Report on submissions and further submissions on the
Proposed Waikato District Plan

Hearing 27D: Coastal Hazards

Response to Submissions on Waikato District Plan Stage 2: Coastal Hazard Area Maps (March 2021). Prepared by Bronwen Gibberd 4D Environmental Ltd and Jim Dahm Eco Nomos Ltd

**Response to Submissions on Waikato
District Plan Stage 2:
Coastal Hazard Area Maps**

Figure 18: Recommended refinement of High Risk Coastal Hazard Area (Erosion) at Greenslade Road

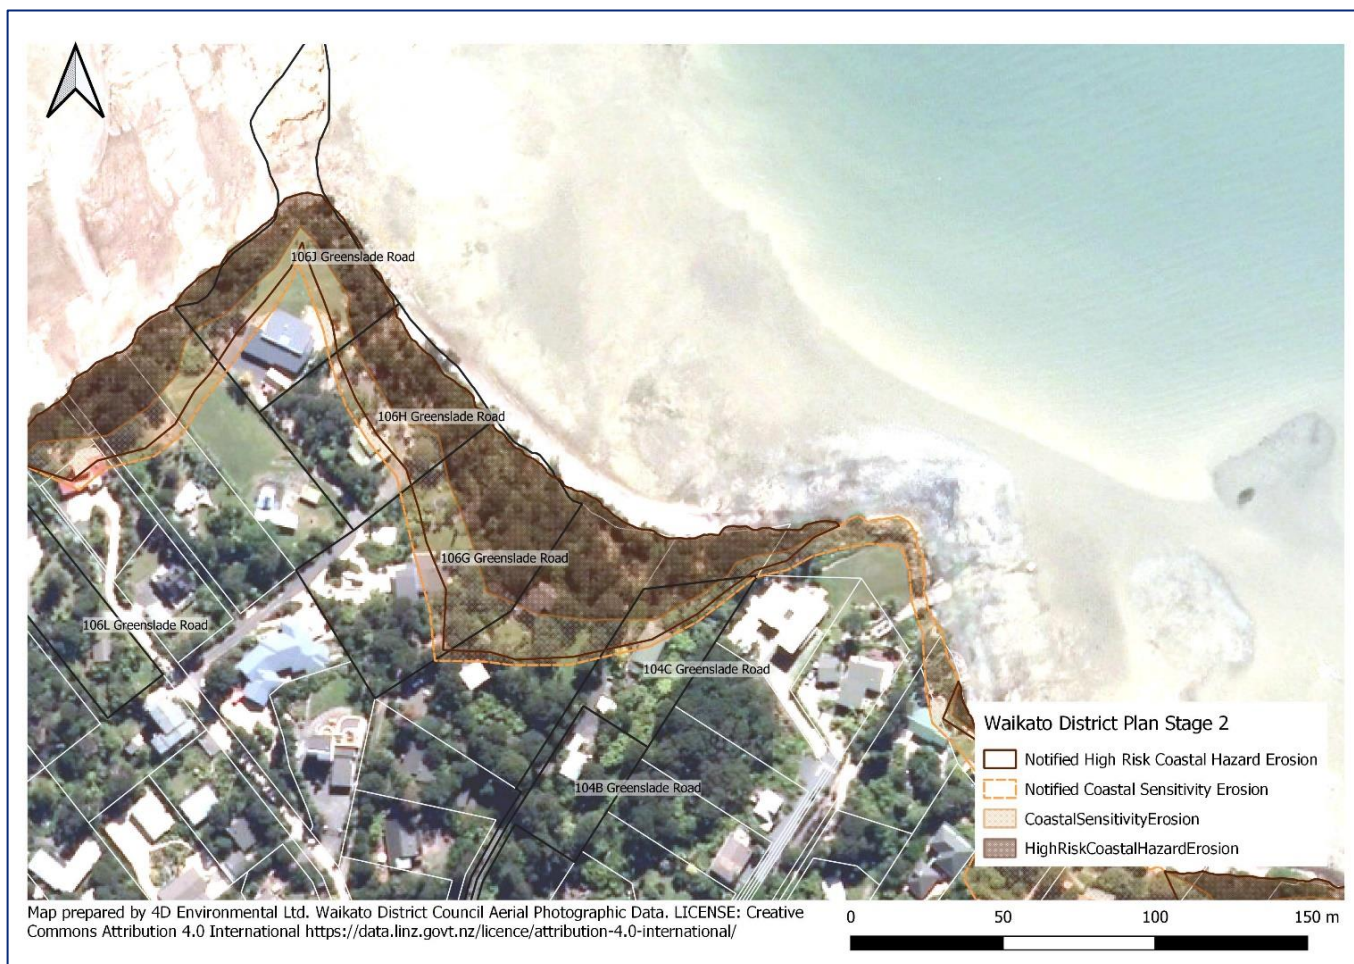
Further field observations were made, with particular attention to a relatively recent (July 2017) slope failure in the Council reserve fronting 104c Greenslade Road (Figure 16). Field measurements and analysis of the DEM data indicates that the slope of this failure is close to 1V:1.5H (Figure 17). This provided useful insight into the potential failure slopes in the area. It is possible that site specific investigations (combined with careful management) may confirm that steeper slopes can be maintained safely, at least in some areas. However, we do not have sufficient data to apply a steeper slope broadly across the area.

We recommend that the High Risk Coastal Hazard Area (Erosion) be amended to reflect a steeper stable slope (1V:1.5H) (shown in Figure 18). While most existing slopes are steeper than 1V:1.5H, this slope provides for failures such as that observed at 104c Greenslade Road. While ongoing management of the cliffs will help to prevent such failures, with current knowledge it is not possible to assume that such actions can limit all future failure to slopes of 1V:1H or steeper.

Figure 20: Coastal inundation overlays at Lorenzen Bay.

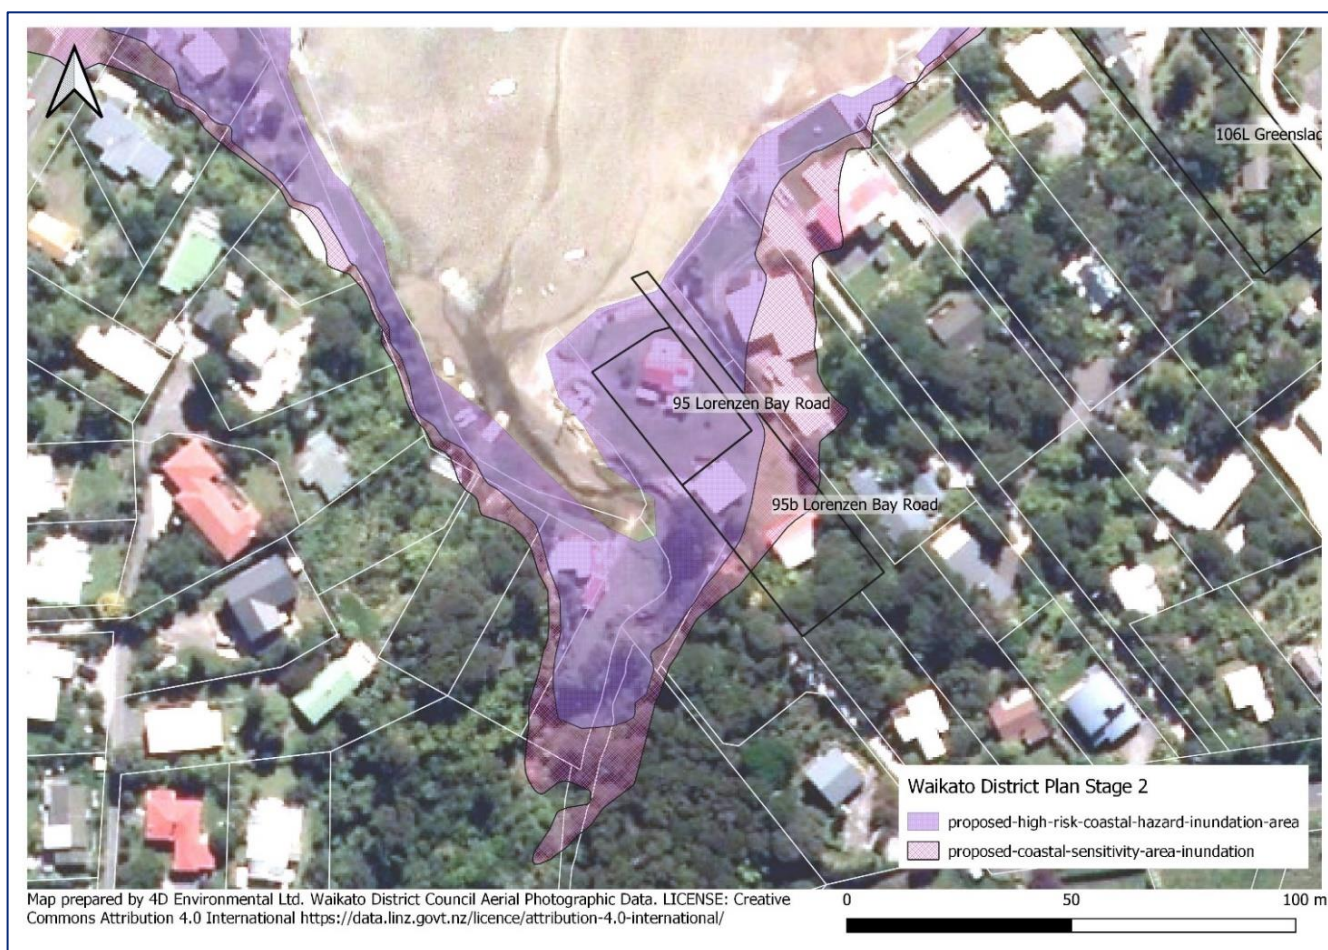
Figure 19 and Figure 20 illustrate the extent to which the Coastal Inundation and Coastal Erosion overlays affect the properties at Lorenzen Bay. Submitters at Lorenzen Bay have objected to the High Risk Coastal Hazard Areas and Coastal Sensitivity Areas on the basis that the properties in question have not been inundated in the past, and are protected by long established seawalls, and that these seawalls have not been breached in the past. Concern is expressed over the significance of the overlays and the potential impact on property values and insurability.

Figure 21: Cross section of 95a and 95b Lorenzen Bay Road, showing an overlay of the ground levels with the defined flood elevations.

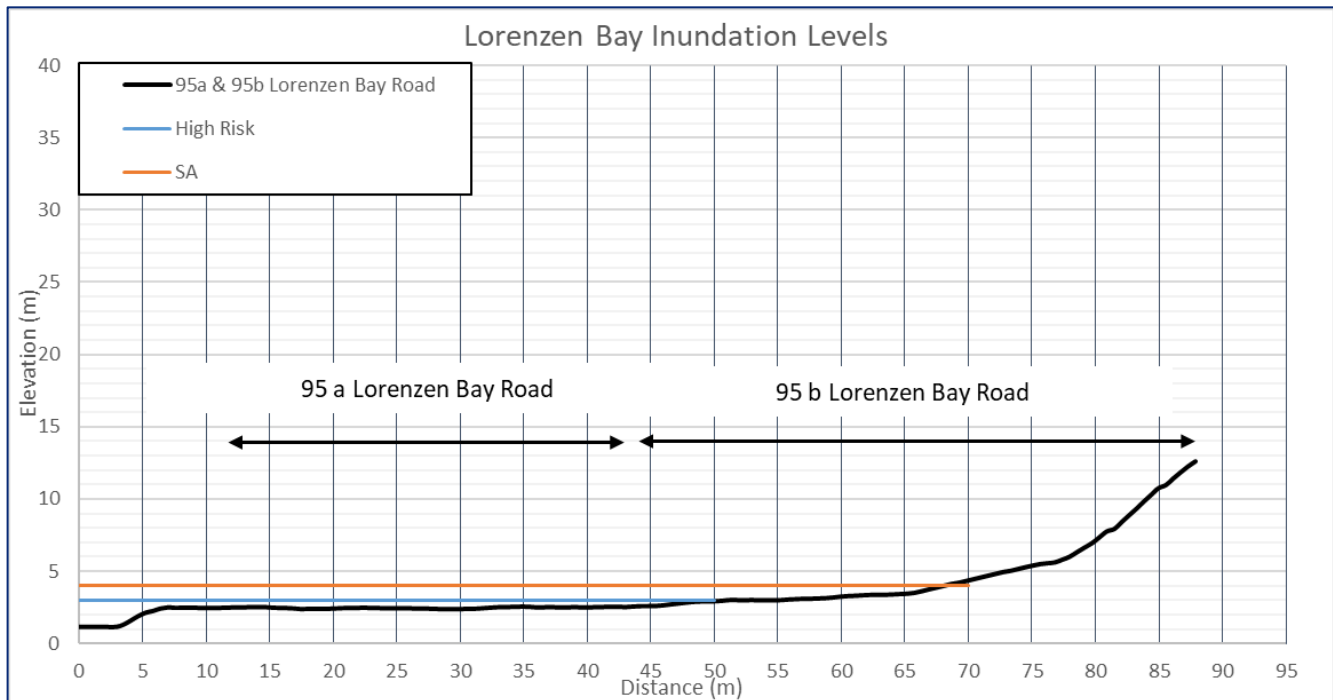
The property at 95 Lorenzen Bay Road is very low-lying, with most of the land at approximately 2.5 m (MVD-53). The most seaward portion of the property at 95b Lorenzen Bay Road lies at approximately 2.8 m (MVD-53) (Figure 21). Both properties are therefore potentially vulnerable to minor flooding in an extreme event with current sea level. Even a minor amount of future sea level rise would greatly increase the frequency and severity of flooding events.

Figure 23: Cross section of 68 Wallis Street, showing an overlay of the ground levels with the defined flood elevations.

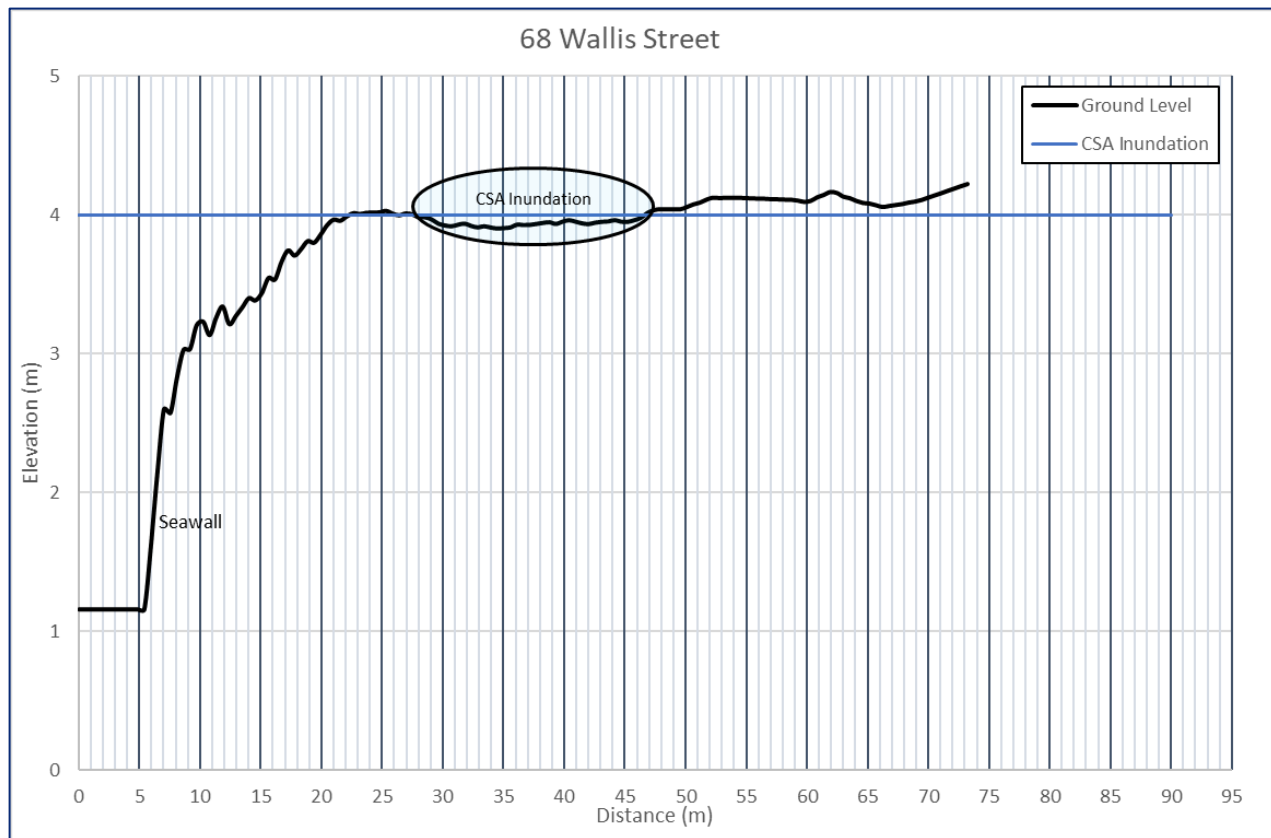
The Coastal Sensitivity Area affects the seaward portion (approximately half) of the property (Figure 22). Examination of existing Lidar data indicates that the section has elevations of approximately 3.9-4.0 m (MVD-53), elevations marginally below the flood elevation used to define the Coastal Sensitivity Area (Figure 23). This means that the lower area of the section may be subject to minor and very occasional flooding during an extreme storm event after 1.0 m of sea level rise. With current sea level, there is coastal inundation hazard is not likely to affect the property, except for a very small area at the most seaward edge.

Given the shallow nature of coastal inundation likely in the next 100 years, coastal inundation hazard is likely to have little effect on the ongoing use of this property. However, it is relevant to note that the elevations used to define the coastal inundation areas do not include wave effects. Areas very close to the shore may be exposed to wave overtopping during extreme events, to an elevation higher than the static storm tide level. The presence of the Coastal Sensitivity Area (Inundation) overlay will ensure these factors are considered when planning future development.

Figure 29: Broad overview of current precincts and future extent of development at Rangitahi Peninsula. Proposed High Risk Coastal Hazard Area (Erosion) and Coastal Sensitivity Area (Erosion) are also shown.

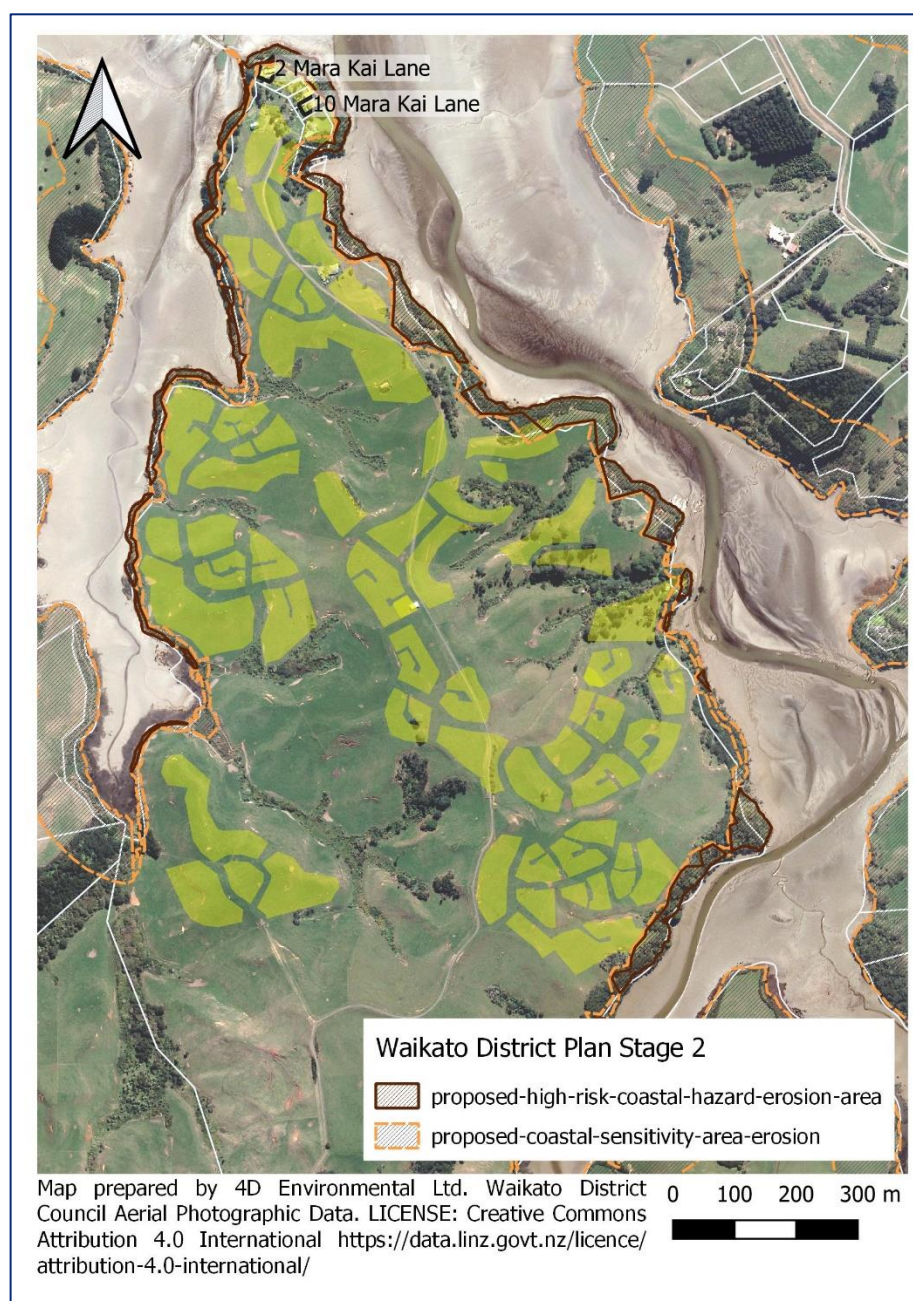
In some areas, the High Risk Coastal Hazard Area (Erosion) and Coastal Sensitivity Area (Erosion) overlap recently subdivided lots. This is particularly significant on the eastern shore of Rangitahi Peninsula in the first stage (Precinct A) of the Rangitahi development (Figure 29).

Figure 30: Properties at Mara Kai Lane, Rangitahi Peninsula, showing notified and revised High Risk Coastal Hazard Area (Erosion) and Coastal Sensitivity Area (Erosion).

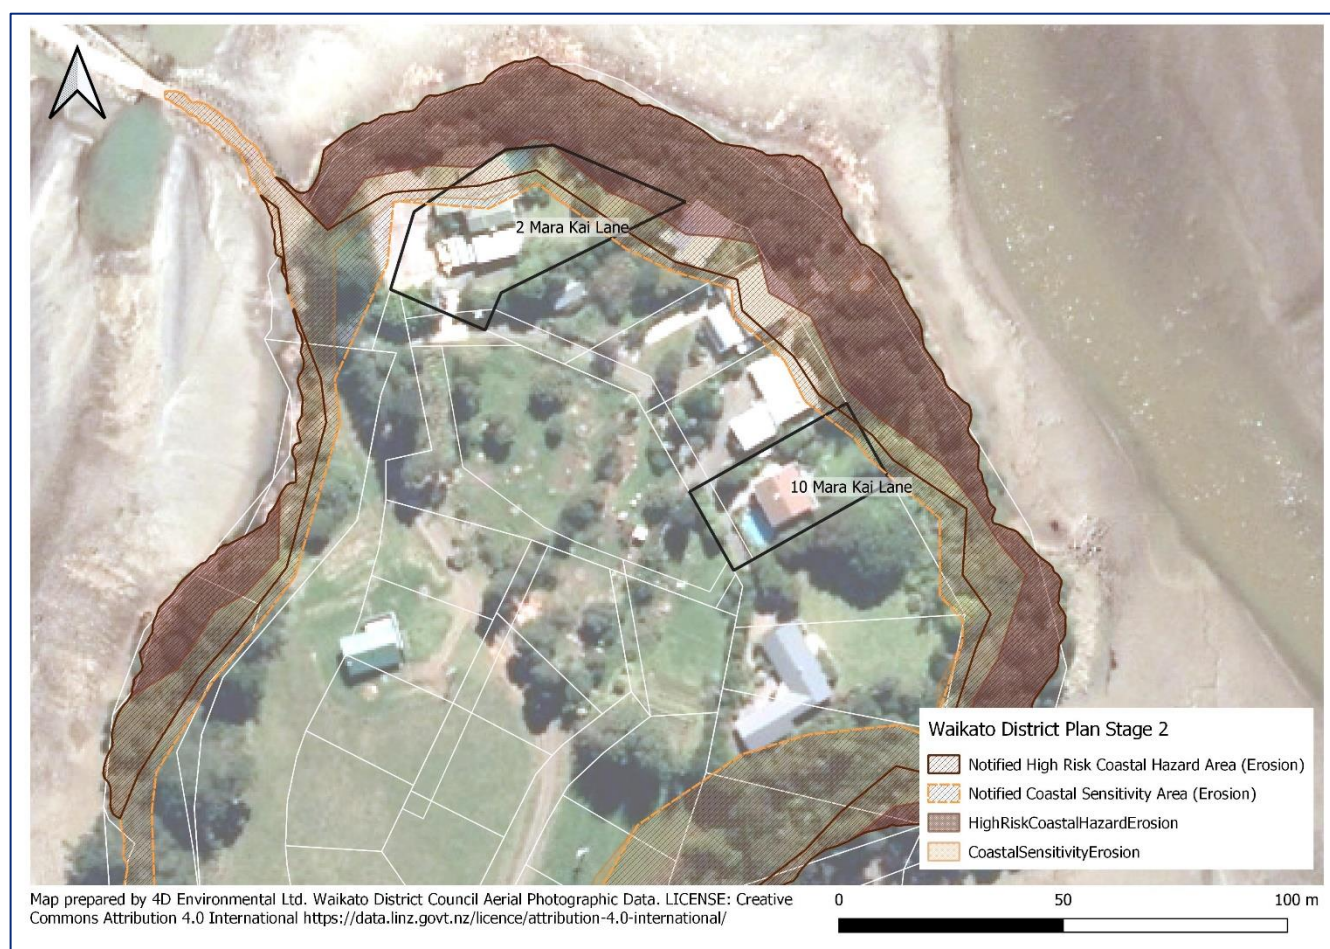
The High-Risk and Coastal Sensitivity Areas both extend across the seaward portion of the property at 2 Mara Kai Lane, including across a part of the existing dwelling (Figure 30). At 10 Mara Kai Lane, the property is only marginally affected by the proposed coastal hazard management areas.

As discussed further in Section 3, we have considered the level of conservatism applied in defining the High Risk Coastal Hazard Area (Erosion), and recommend that the High Risk area be refined to reflect a steeper 1V:1.5H slope (Figure 30). This slope is consistent with observed slopes, and recent landslides in similar settings within Raglan Harbour and represents the area of greatest risk for slope instability.

More significant land instability cannot be disregarded based on current information, so we recommend retaining the Coastal Sensitivity Area (Erosion) as notified, to ensure full consideration is given to the extent of site-specific coastal hazard. As discussed in Section 3, this Sensitivity Area is not a defined “hazard” area, but simply a recognition of the need for coastal processes and hazards to be considered. Some existing dwellings on Mara Kai Lane are located within this Coastal Sensitivity Area (Erosion).

Figure 33: Extent of Coastal Sensitivity Area (Inundation) and Coastal Sensitivity Area (Erosion) overlays at 201-209 Ohautira Road.

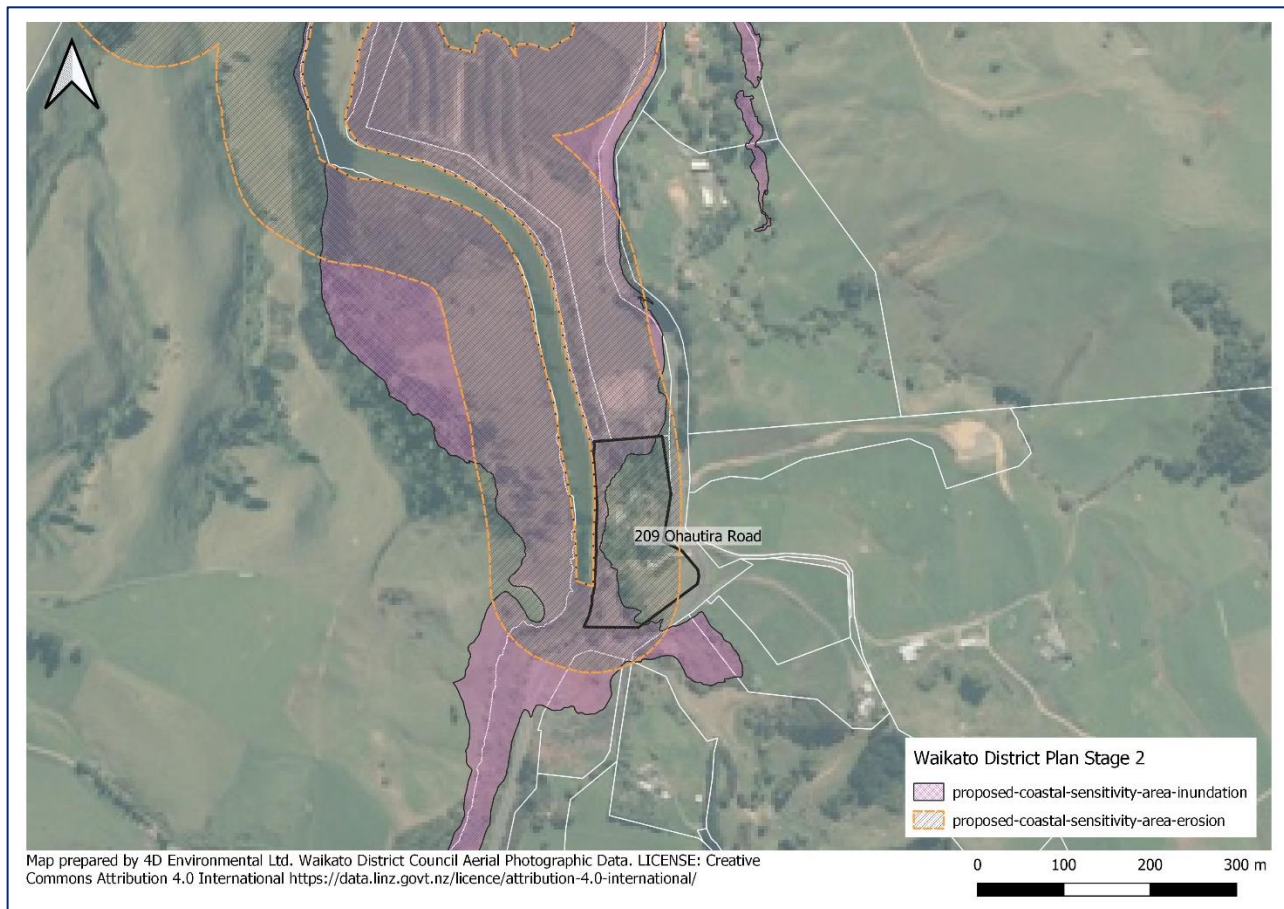
The Coastal Sensitivity Area (Inundation) covers the low-lying portions of the property at 201 and 209 Ohautira Road, adjacent to Waitetuna River (Figure 33). The mapped extent of this sensitivity area represents an area that is potentially vulnerable to the effects of extreme water levels and coastal inundation including inundation that may occur during an extreme event after sea level rise over the next 100 years.

The Coastal Sensitivity Area (Erosion) in this area (rural estuarine shoreline) is defined by a 100 m buffer from the shoreline and is present over the full width of the property. This is not a defined “hazard” area but highlights that coastal processes and hazards should be considered. The width of the zone reflects the variability in shoreline geology and topography around Raglan Harbour. This is discussed further in Section 3.

Figure 34: Location of properties at 5 Aroaro Lane, 27 Primrose Street and 3b Lily Street. Coastal Inundations overlays are shown.

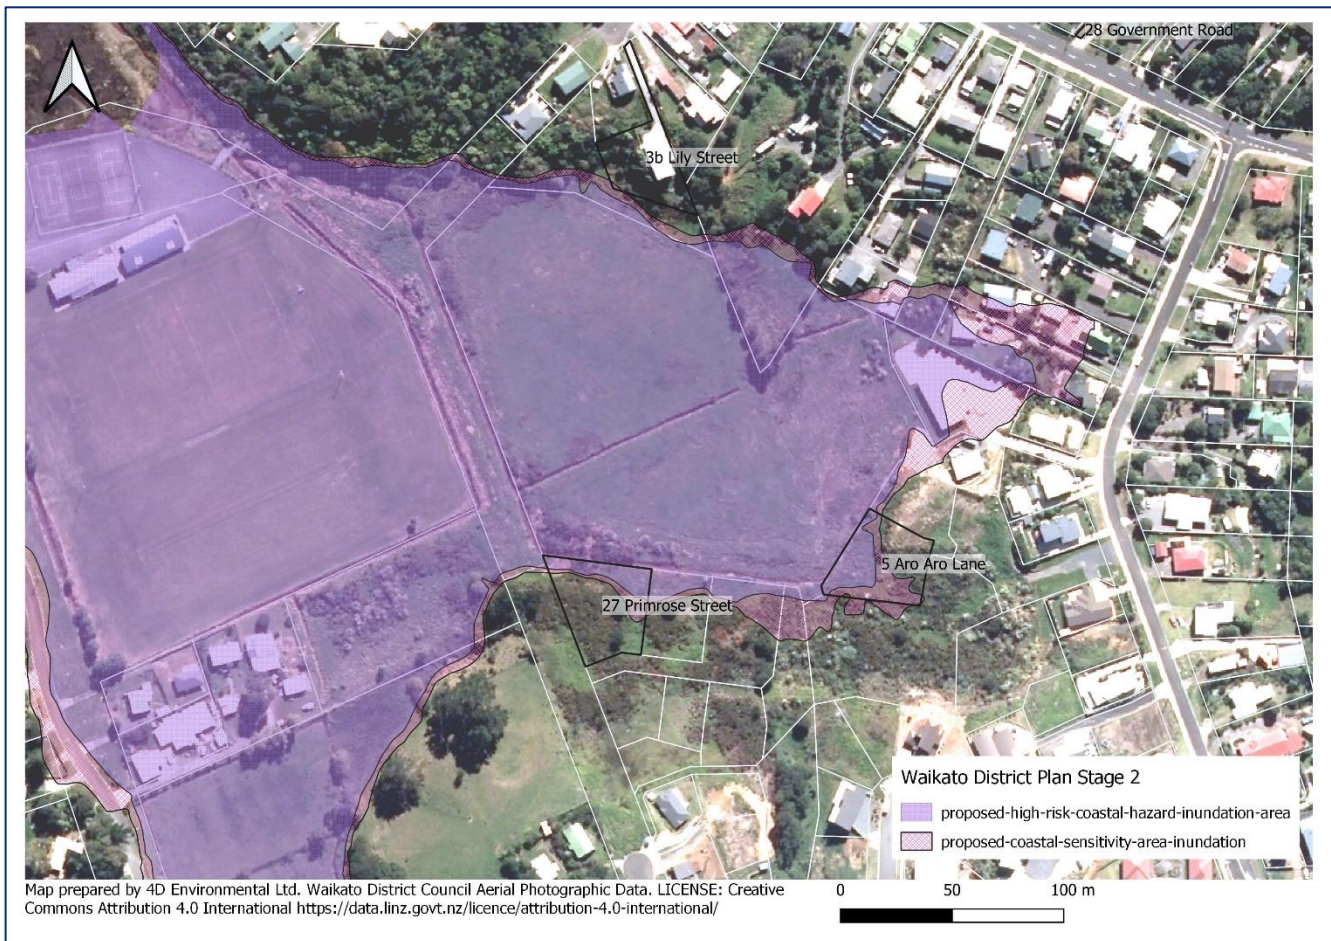
The western half of the property at 5 Aroaro Lane varies in elevation (2-5 m MVD-53) and is therefore partly within the High Risk Coastal Hazard Area (Inundation) and Coastal Sensitivity Area (Inundation) overlays (Figure 34).

The available Lidar data indicates that most of the property at 27 Primrose Street is well above the level of any foreseeable coastal inundation hazard. The building platform lies at approximately 5.5-6.5 m MVD-53. The northern boundary of the property is adjacent to the same drained wetland as discussed above (submission #2169) (Figure 34).

Almost all of the property at 3b Lily Street is well above the level of any foreseeable coastal inundation hazard. The building platform lies at approximately 15 m MVD-53. The southern boundary of the property is adjacent to the same drained wetland as discussed above (submission #2169 & #2039). The Coastal Sensitivity Area (Inundation) overlay is limited to a very small corner of the property (approximately 7 m²) (Figure 34). Provisions that relate to this overlay will only apply within this very small area and do not affect the remainder of the property.
